IN RE:)
)
Seidner Residences) KETCHUM PLANNING AND ZONING COMMISSION
Preliminary Plat) FINDINGS OF FACT, CONCLUSIONS OF LAW, AND
Application File Number: P26-016a) DECISION
Date: July 16, 2026)
)
)

PROJECT: Seidner Residences

APPLICATION TYPE: Townhouse Subdivision Preliminary Plat

FILE NUMBER: P26-016a

Figure 1: Subject property outlined in red, referenced properties outlined in orange.

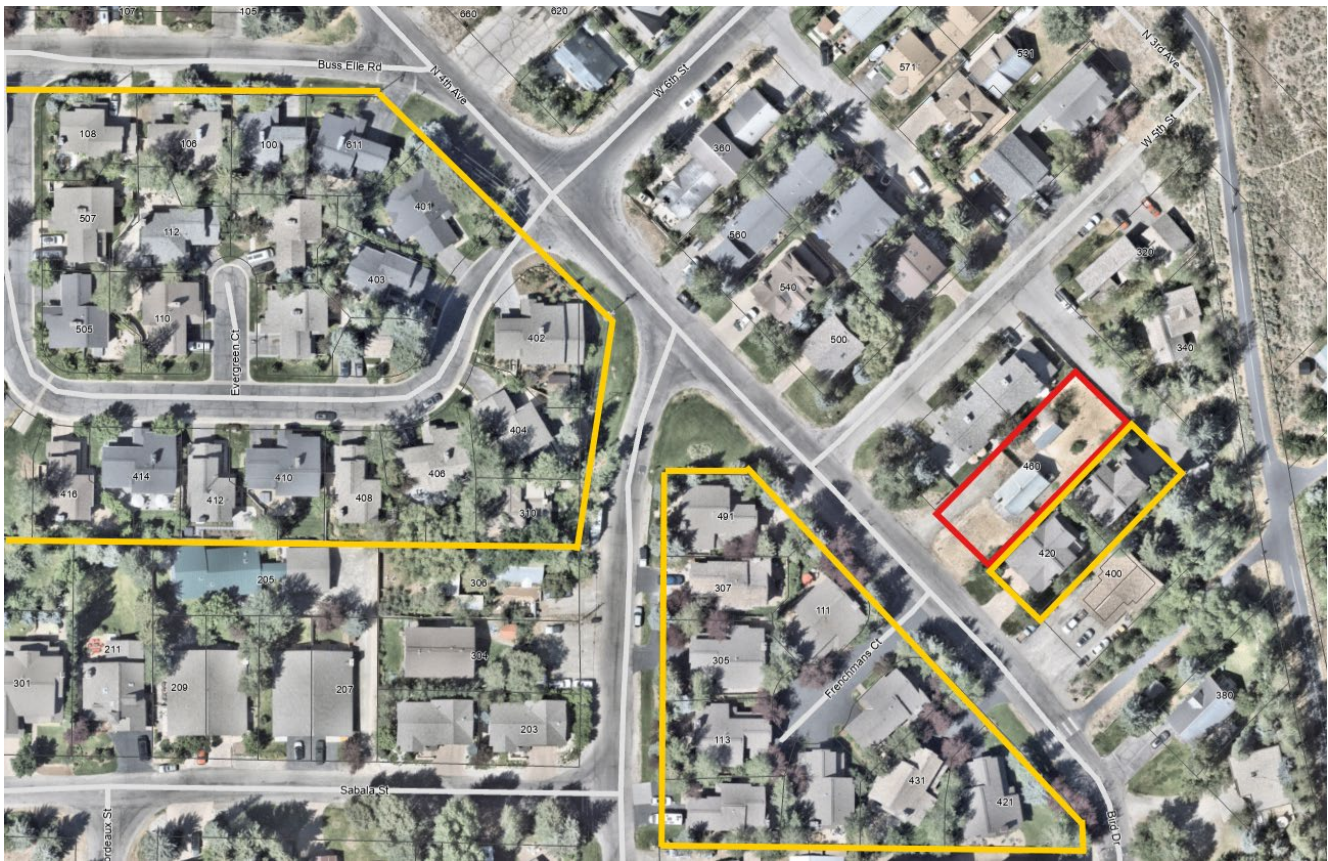
The Commission finds that the proposed townhomes align with the MDR FLUM category. The project is calculated at 8.69 dwelling units per acre, falling within the desired range of five to eleven. Parking is provided in garages (two car garage for Unit A and one car garage for Unit B) with one designated spot in the driveway for Unit B. The tall/narrow buildings with pitched roofs and a prominent window feature over a garage & entrance complement the neighborhood size and character. The proposed setbacks are within the scale and pattern of the neighborhood as two dense PUD’s (The Pines and Frenchman’s Townhomes) are down the road and across the street. Furthermore, the proposed

detached townhomes match the pattern of the adjacent property at 420 N 4th (detached townhomes with access fronting 4th Ave and the rear alleyway). See figure 2 for a vicinity map.
